REAR WHEEL SPOKES / SX-175 WITH WELDED STEEL HUB

HARLEY-DAVIDSON MOTOR CO., INC.

SPOKE RETAINER INSTALLATION

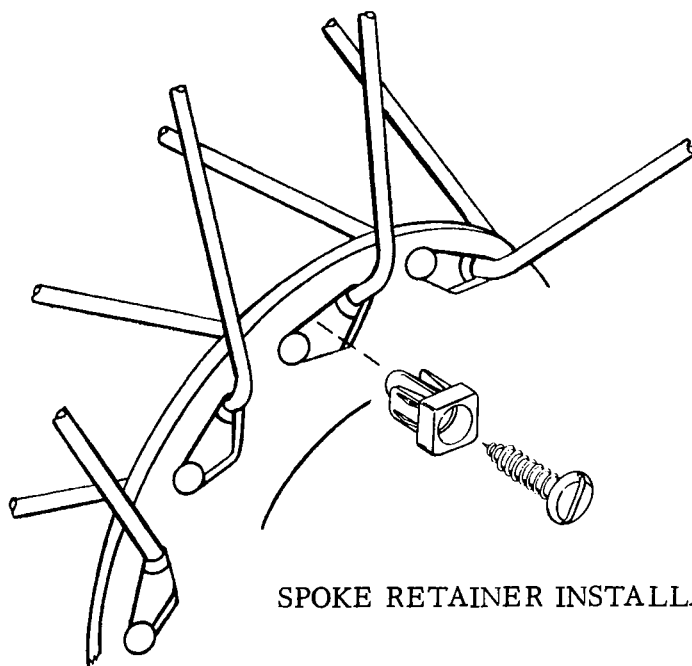
On late 1975 SX-175 motorcycles, positive retention of the rear wheel spokes in the right side hub flange is accomplished by using washers underneath the spoke heads.

As an interim change some early 1975 motorcycles have nylon plugs installed between the spoke hooks in each slotted hole to accomplish the same purpose.

Any 1974 SX-175 motorcycles with welded steel rear wheel hub used for off-road service should be equipped with nylon plugs, part No. 70574-68 secured with part No. 2623W screws in each of the nine (9) slotted holes as shown below.

This will prevent the possibility of spoke heads unhooking from the wheel hub in case spokes become excessively loose.
